# SERVICE BULLETIN

M-1163

Safety Recall Code 0116

## DYNA GLIDE P&A VOLTAGE REGULATOR COVER

Figure 1. Dyna Glide P&A Voltage Regulator Cover Kit (Part No. 74593-04)

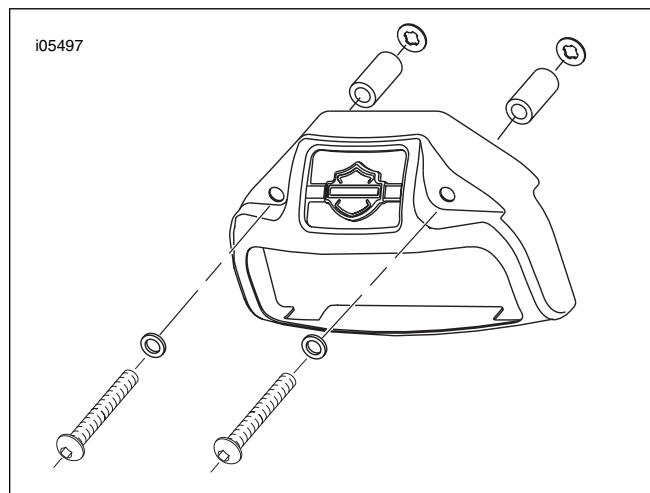
As recently advised in ML-395, Harley-Davidson has learned that normal front suspension travel, under certain riding conditions, could allow the rear tip of the front fender to become locked in the voltage regulator cover installed on certain 2004-05 Dyna Glide motorcycles. By severely limiting front suspension travel and steering, this condition can present an unreasonable risk of accident, injury or death.

1. Remove two button head screws to remove voltage regulator and voltage regulator cover assembly from frame crossmember. Set cover assembly aside for return to Harley-Davidson.

*The cover assembly consists of two button head screws, two chrome plated washers, the voltage regulator cover, two zinc spacers, and two nylon retaining washers. See Figure 1.*

2. Reinstall voltage regulator using two **new** screws (Part No. 4740A) obtained from your inventory.
3. Alternately tighten screws to 60-80 **in-lbs** (6.8-9.0 Nm).
